SECTION 4.0 REVISIONS TO THE TEXT OF THE DRAFT PEIR

4.1 CHANGES TO THE PROJECT DESCRIPTION SINCE CIRCULATION OF THE DRAFT PEIR

Revisions to the Proposed DSAP/General Plan Land Use Designations

Below are revisions to the text of the Draft PEIR based on the changes to the Project Description for the Diridon Station Area Plan, dated December 2013. Revised or new language is underlined. All deletions are shown ~~with a line through the text~~.

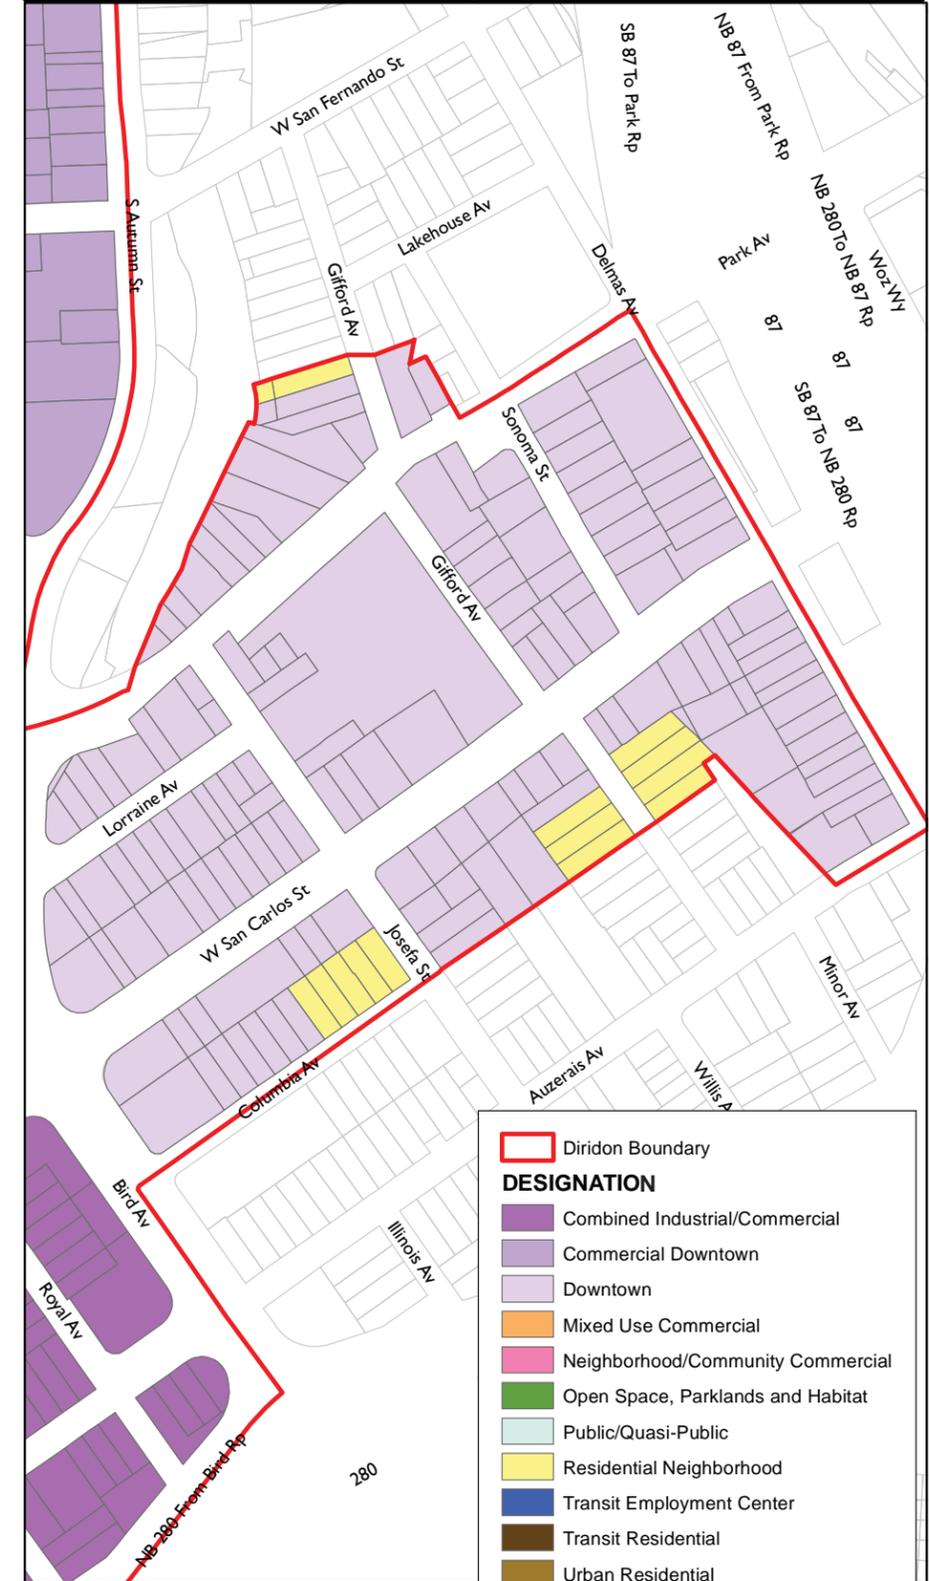
Since the Diridon Station Area Plan Program EIR circulated, the City has determined that fewer changes to the 2040 Envision San José General Plan Land Use Transportation Diagram are required within the DSAP area; specifically, within the Park/San Carlos subarea. This subarea is located in the Southern Zone of the DSAP, generally between north of Park Avenue and south of West San Carlo Street, east of Autumn Street and west of Delmas Avenue. The Park/San Carlos subarea includes the Delmas Park neighborhood, as shown on the figure on the following page.

The originally proposed Urban and Transit Residential designations would have allowed for residential development up to 95 DU/AC and 250 DU/AC respectively, compared to up to 350 DU/AC with the *Downtown* designation. Since the PEIR was circulated, it has been determined that changing the designations on many of the properties within the Park/San Carlos subarea is not required to meet the objectives of the project. In fact, the existing *Downtown* designation allows projects to have smaller units that could be affordable by design or by their small size, and fit within the intended scale and height of development envisioned by the DSAP and the Delmas Park Strong Neighborhoods Initiative Plan.

The *Downtown* land use designation allows more flexibility for commercial uses than the *Transit Residential* Designation, which supports both residential and residential-commercial mixed use development but does not support stand-alone commercial uses. Allowing stand-alone commercial uses is consistent with and could further the city's ambitious jobs goals in the General Plan. The *Neighborhood/Community Commercial* designation does not allow residential mixed use development and is therefore, inconsistent with the DSAP. For these reasons, the *Downtown* designation is preferred over the *Urban Residential*, *Transit Residential*, and *Neighborhood/Community Commercial* designations for the properties within the Subarea.

(REVISED) FIGURE 2-2

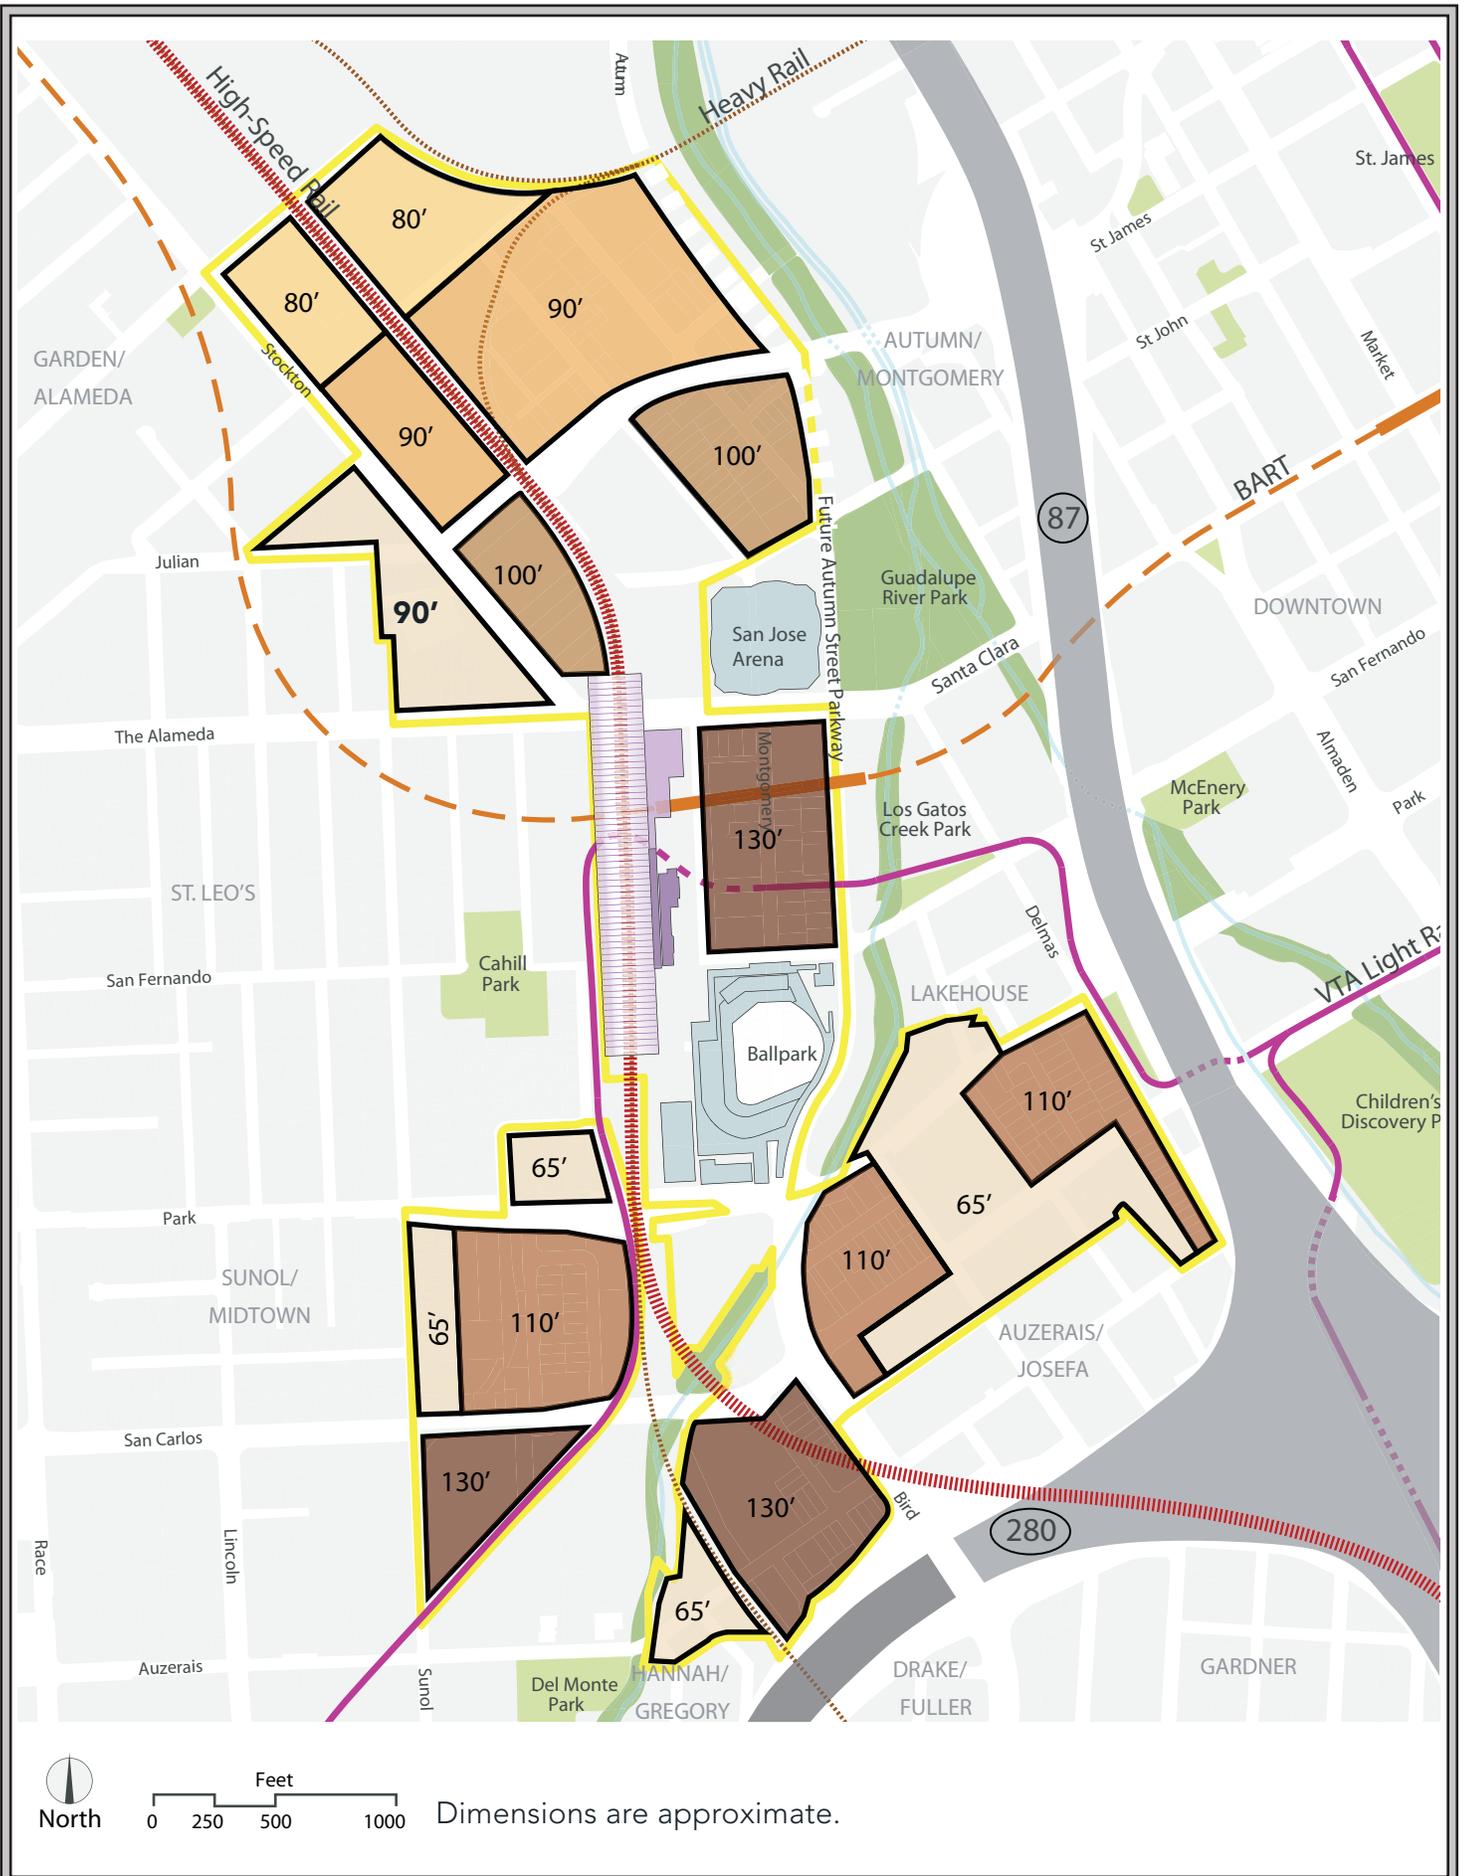
Page 43 *Figure 2-2; REVISED* as included at the end of this section.

(REVISED) FIGURE 2-3

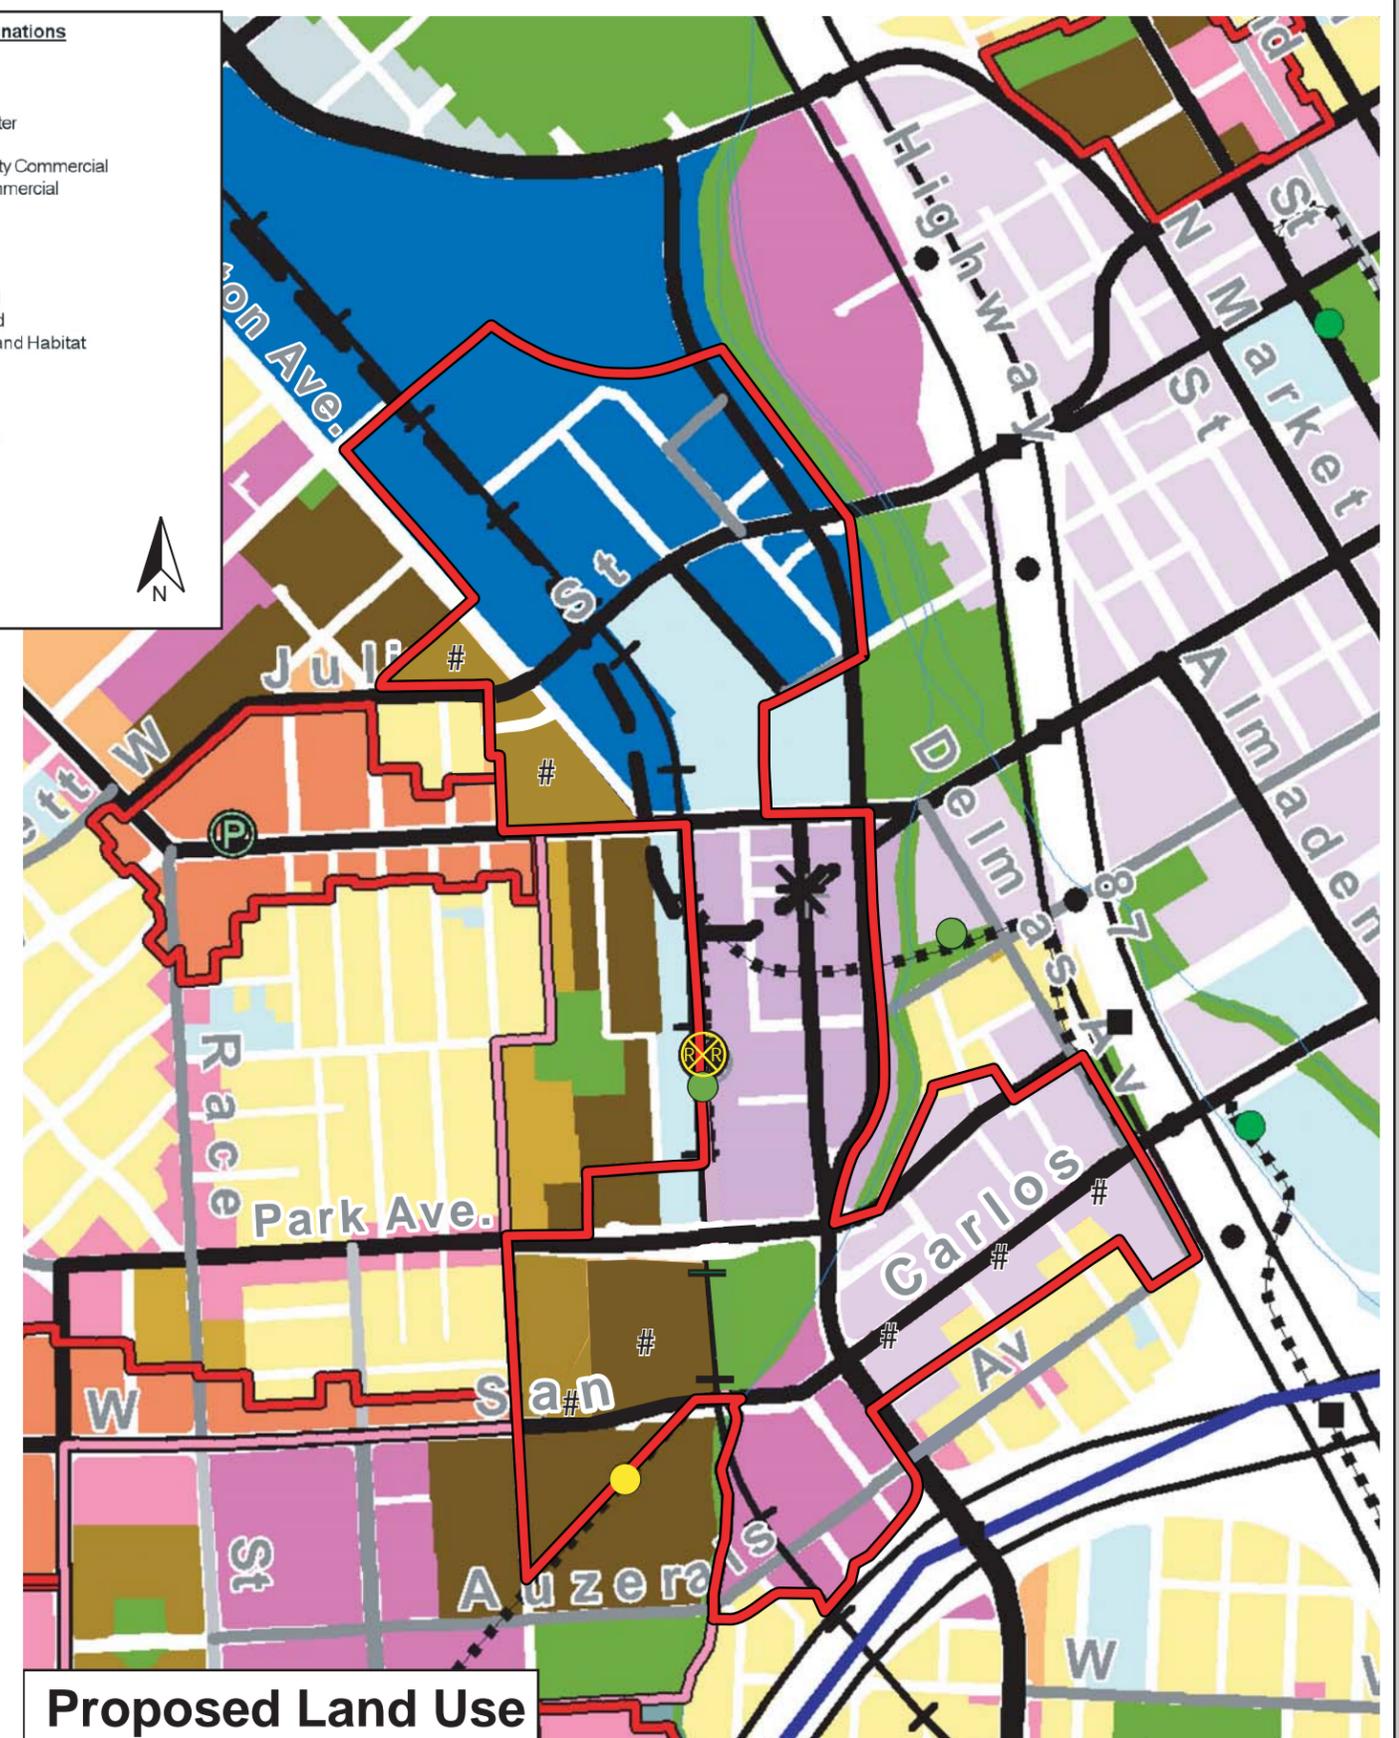
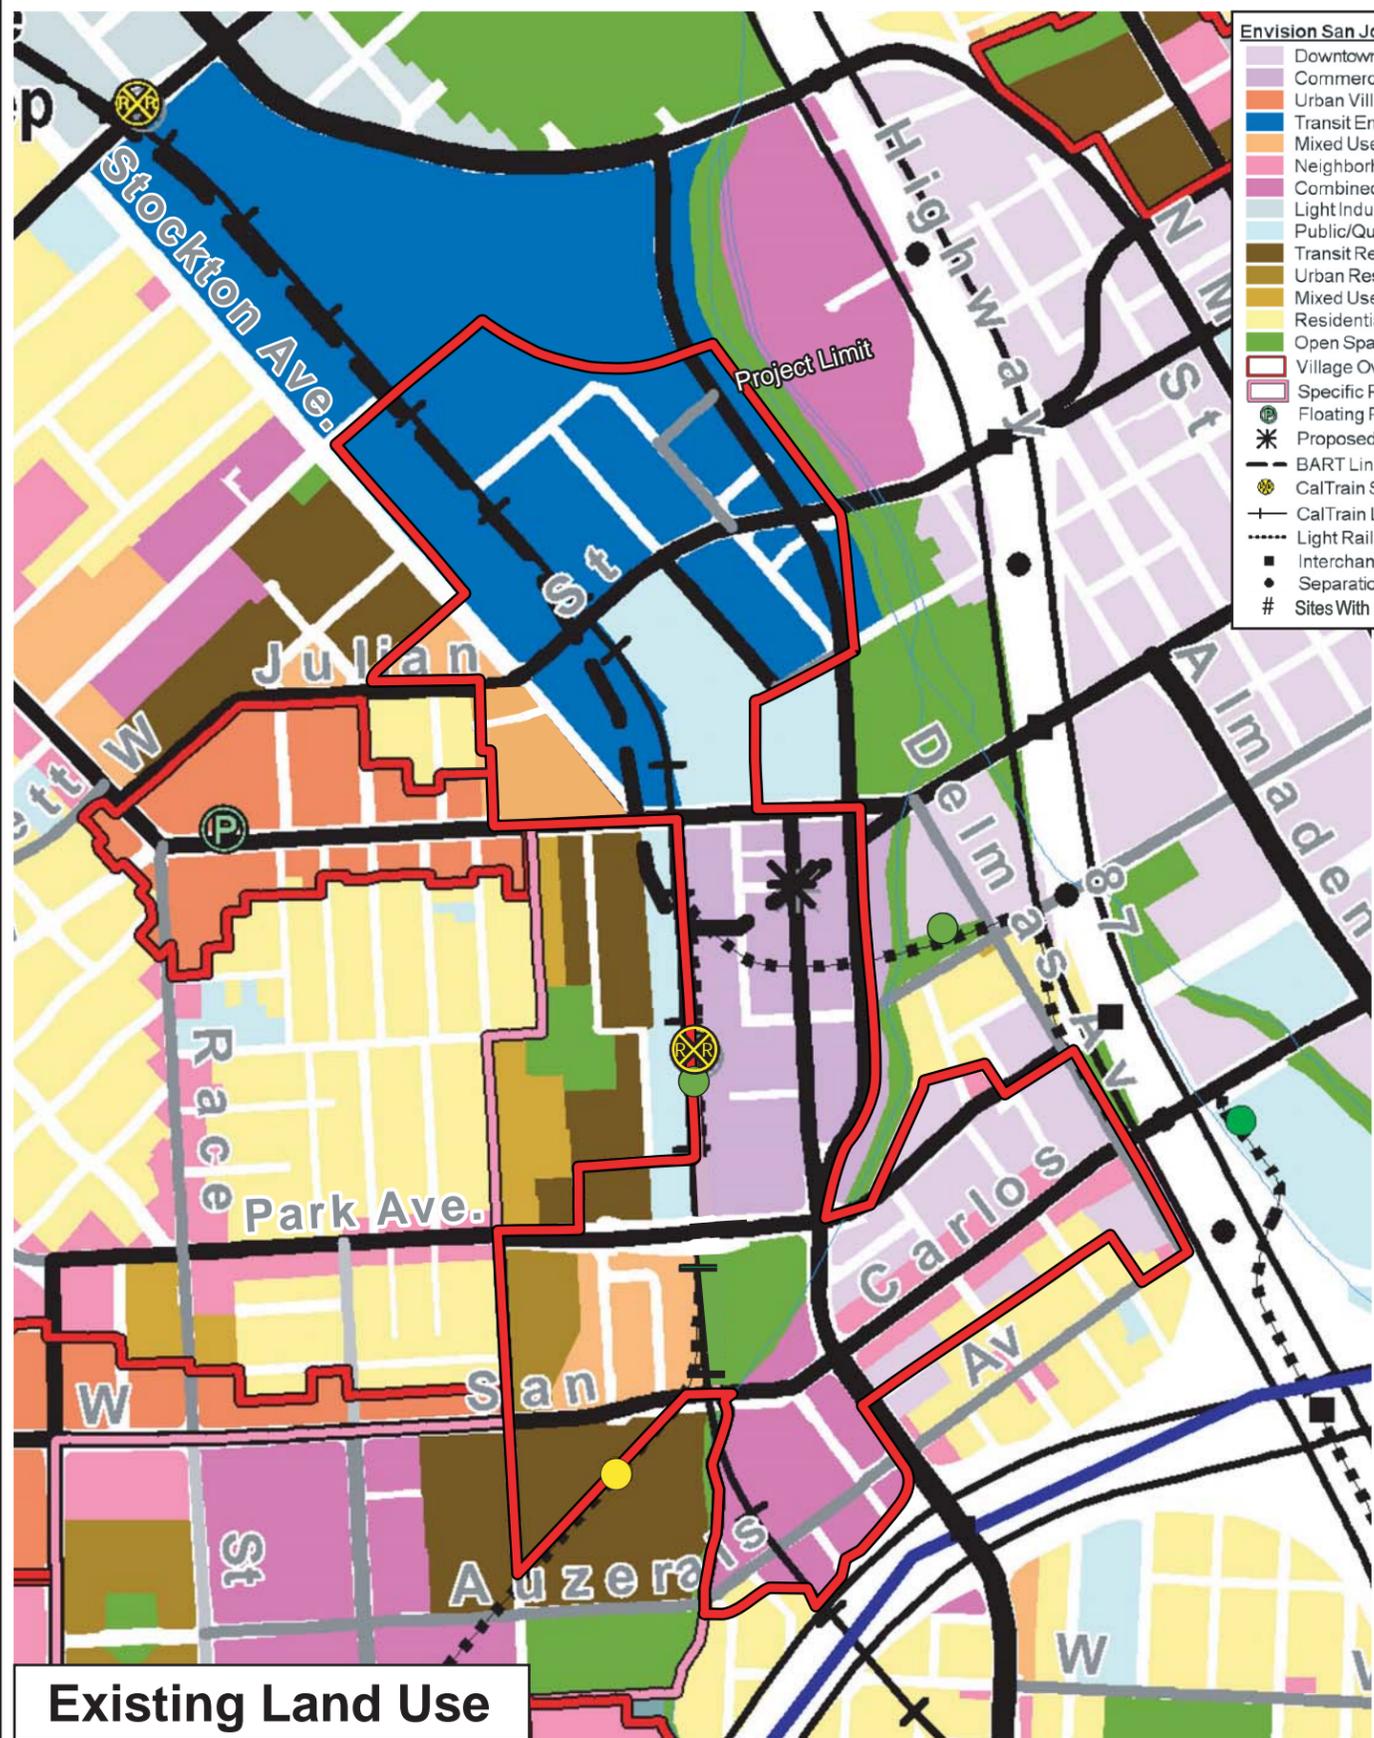
Page 44 *Figure 2-3; REVISED* as included at the end of this section.

(REVISED) FIGURE 2-4

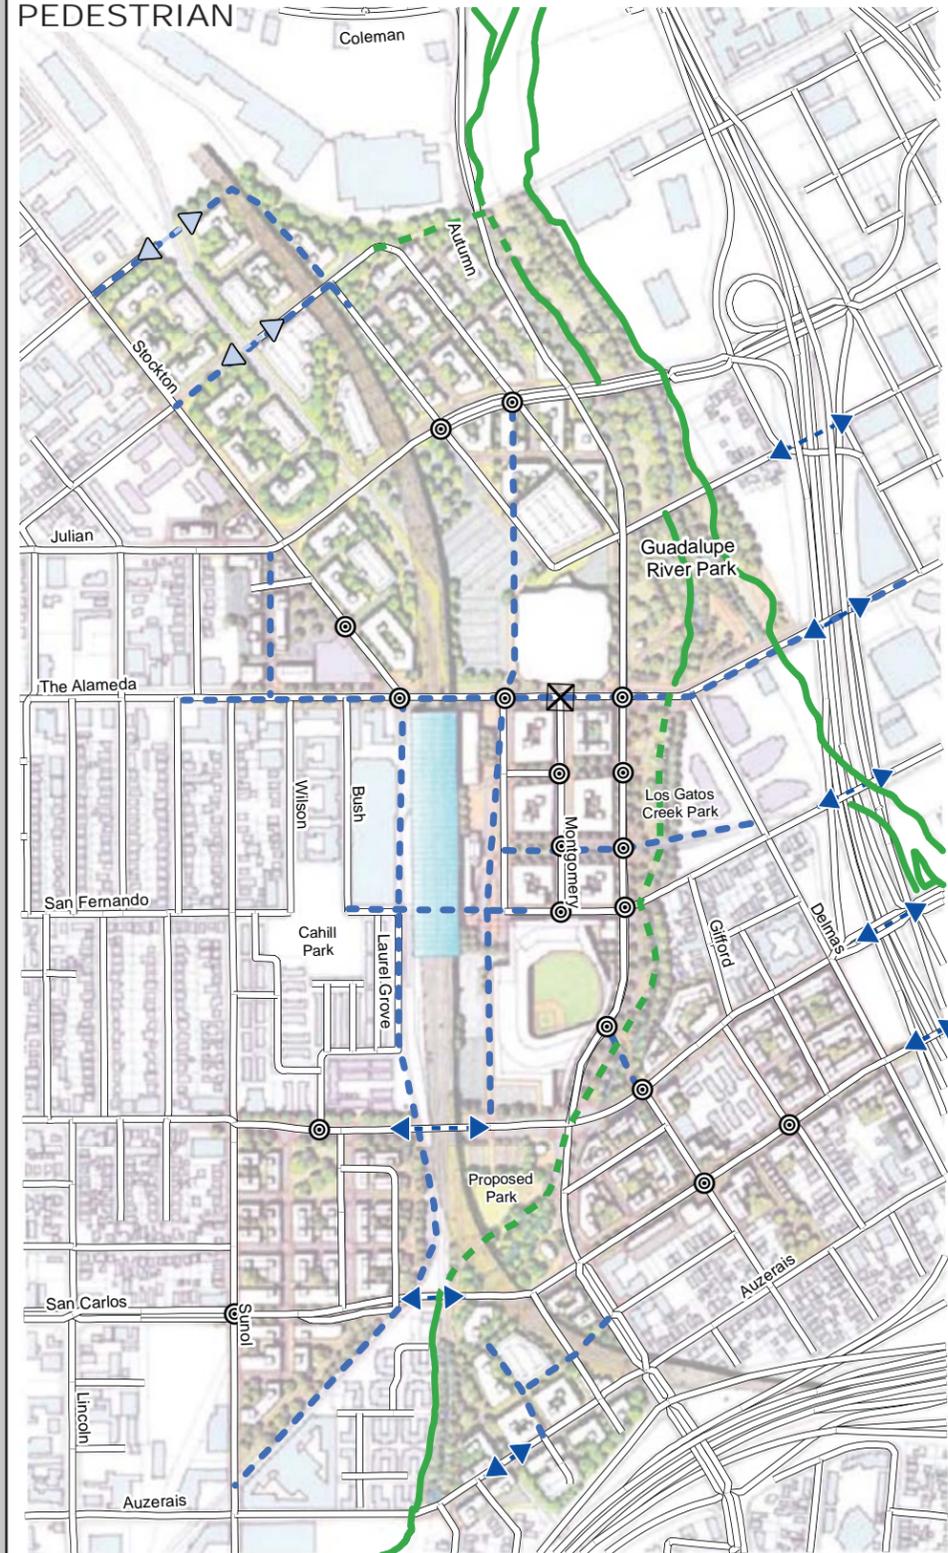
Page 50 *Figure 2-4; REVISED* as included at the end of this section.
